Project	IEEE 802.16 Broadband Wireless Access Working Group < http://ieee802.org/16 >	
Title	Comments on T48 timer	
Date Submitted	2008-03-13	
Source(s)	Kanchei (Ken) Loa, Yi-Hsueh Tsai, Yung-Ting Lee, Hua-Chiang Yin, Shiann-Tsong Sheu, Youn-Tai Lee	Voice: +886-2-66000100 Fax: +886-2-66061007 loa@iii.org.tw
	Institute for Information Industry 7F, No. 133, Sec. 4, Minsheng E. Rd., Taipei City 105, Taiwan	
Re:	IEEE 802.16-08/007: "IEEE 802.16 Working Group Letter Ballot Recirc #28b: Announcement"	
Abstract	This contribution proposes modification on connections for RS	
Purpose	Text proposal for 802.16j Draft Document.	
Notice	<i>This document does not represent the agreed views of the IEEE 802.16 Working Group or any of its subgroups. It represents only the views of the participants listed in the "Source(s)" field above. It is offered as a basis for discussion. It is not binding on the contributor(s), who reserve(s) the right to add, amend or withdraw material contained herein.</i>

Comments on T48 timer

Kanchei (Ken) Loa, Yi-Hsueh Tsai, Yung-Ting Lee, Hua-Chiang Yin, Shiann-Tsong Sheu, Youn-Tai Lee
Institute for Information Industry (III)

Figure 115a—Handling CDMA ranging code at a transparent RS

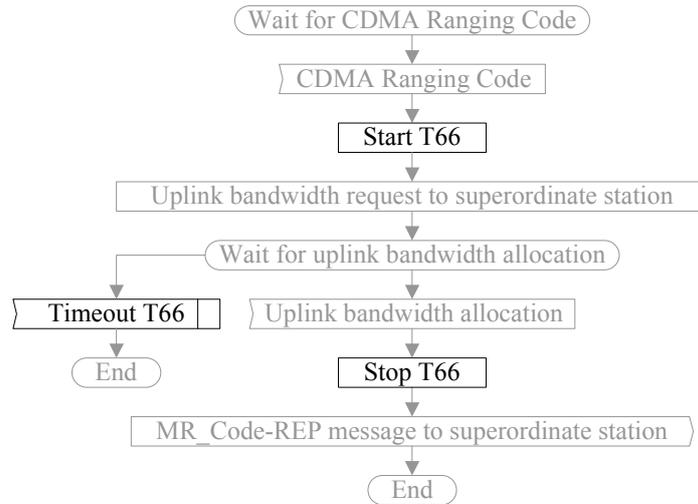
[Modified T48 by T65 in Figure 115a as following indicates:]

The third scenario is that the transparent RS starts the T48 timer to wait for bandwidth allocation for sending MR_Code-REP message to the superordinate access station. The semantic of this timer is different from the T48 timer, therefore, we propose a new T66 timer.

- The RS shall monitor the Ranging Channel specified in the UL-MAP broadcasted by the MR-BS for initial ranging codes. When the RS detects one or more codes in a frame received on the access link, it shall send the codes it receives with sufficient strength and their adjustment information (e.g. time, power, frequency corrections) in an MR Code-REP message on the RS basic CID to the serving MR-BS within T66 interval.

Figure 115k—Handling CDMA ranging code or MR Code-REP message at an MR-BS

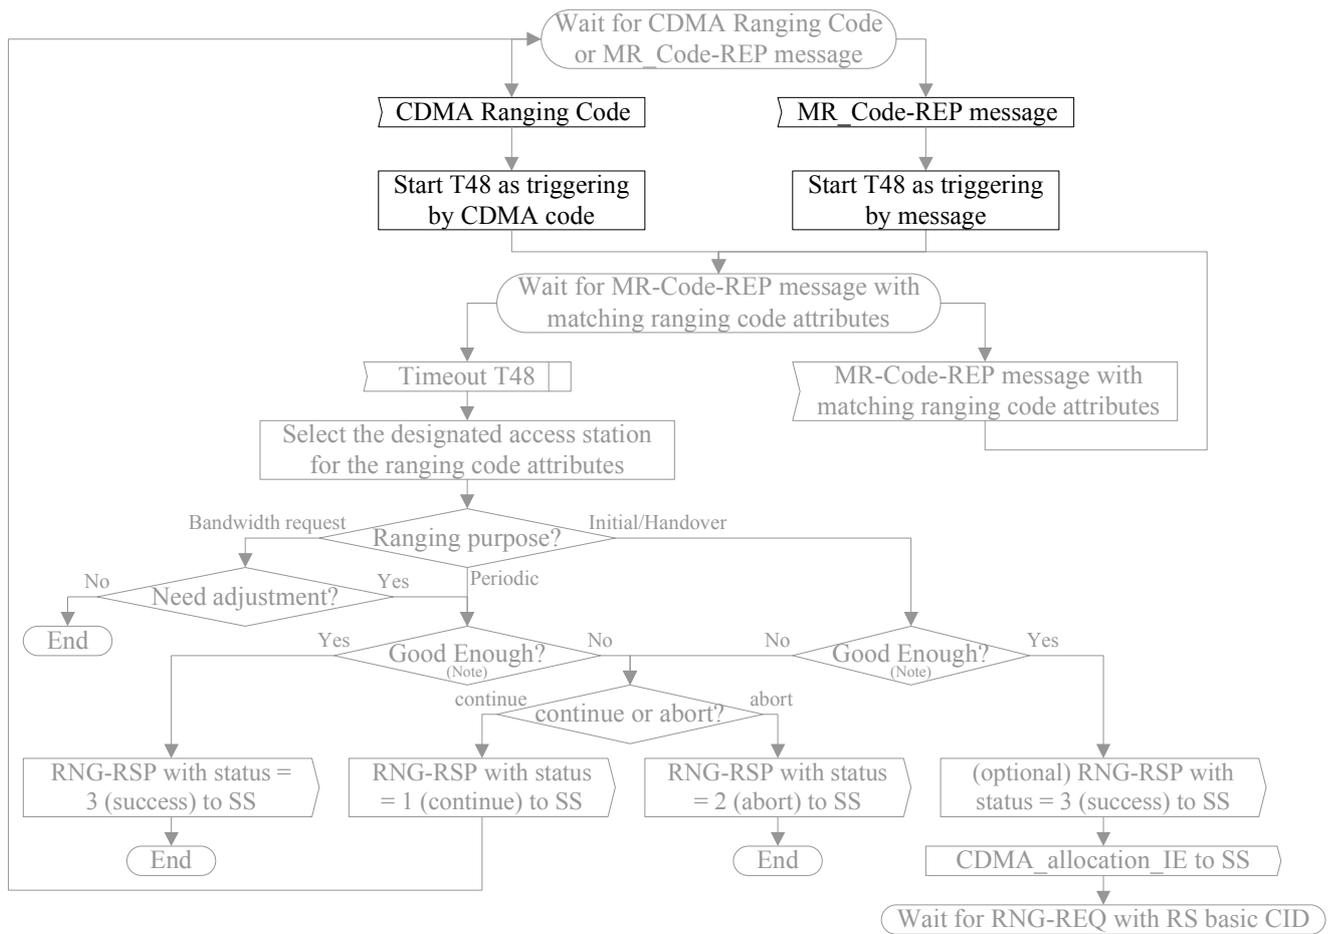
[Modified Figure 115k as following indicates:]

In current draft standard, the T48 timer has three values in different scenarios. One scenario is that the superordinate access station starts the T48 timer after receiving CDMA ranging code; another scenario is that the superordinate access station starts the T48 timer after receiving MR_Code-REP message. We propose to modify Table 583 and related text and flow chart such that they are consistent.

- When an MR-BS first receives a CDMA ranging code directly or via an MR Code-REP message, it shall set the T48 timer and wait for other MR Code-REP messages to arrive with the same ranging code attributes from other subordinate RSs. Once the T48 timer expires, the MR-BS shall determine the most appropriate path (direct or via an RS) on which to communicate with the SS that originated the code. Algorithms or policies to select the path are out of scope of this document.
